Discussion of DNR Comments on Changes to Water Supply Infrastructure and Environmental Impacts with a Hypothetical Low Water Demand

PREPARED FOR: Wisconsin Department of Natural Resources

PREPARED BY: CH2M HILL

DATE: March 24, 2014

Figure 16

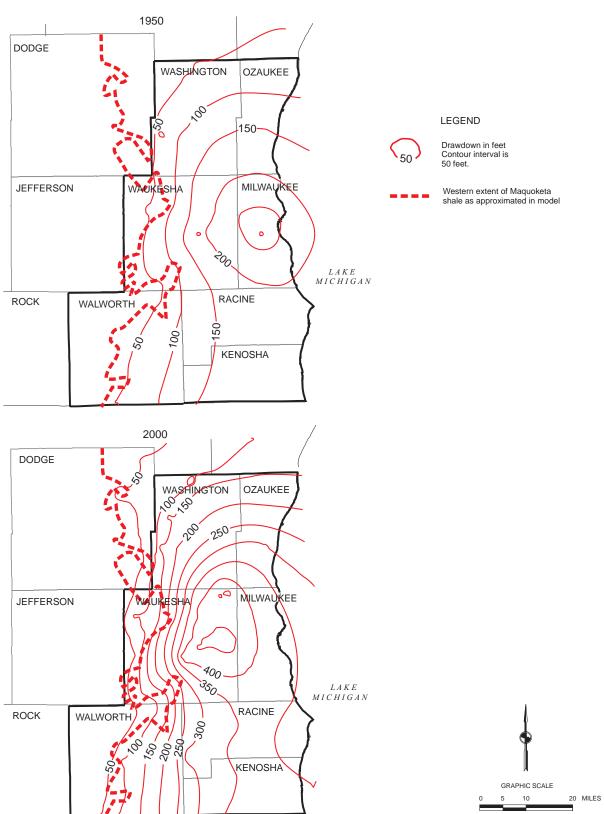
1. In Table 2 for Alternative 5 – the memo indicates at the 2 MGD pumping scenario the drawdown is greater than 150 ft. The modeled drawdown for the 2 MGD scenario is actually reported to be 40 feet in Exhibit 11-34 of volume 2 of the current application. In addition, the modeled drawdown at 10.5 MGD is reported in the application to be slightly more than 150 ft. Thus, [it may not be] a reasonable assumption that the modeled drawdown for an 8.5 MGD withdrawal would be 150 ft or greater. Please correct the memo to address these concerns.

Response: The drawdown shown in Exhibit 11-34 of Volume 2 of the Application is the change in drawdown from recent baseline conditions. It does not compare the drawdown to predevelopment conditions, which is the basis for designation as a groundwater management area under Wisconsin Administrative Code Chapter NR 820. The recent baseline condition is approximately 100 feet below predevelopment conditions, as reflected in the Southeastern Wisconsin Regional Planning Commission's (SERWPC's) A Regional Water Supply Plan for Southeastern Wisconsin (SEWRPC, 2010) (See Figures 16, 17, and 18 included as Attachment A for convenience). Consequently, withdrawal of 2 million gallons per day (mgd) results in an additional 40 feet of drawdown or a total drawdown of approximately 150 feet compared to predevelopment conditions. Because the 10.5 mgd analysis reported a drawdown of 150 feet from recent conditions or a total of approximately 250 feet from predevelopment conditions, a hypothetical average day demand (ADD) of 8.5 mgd will easily have a drawdown of 150 feet or greater compared to predevelopment conditions. No change to the memo is necessary.
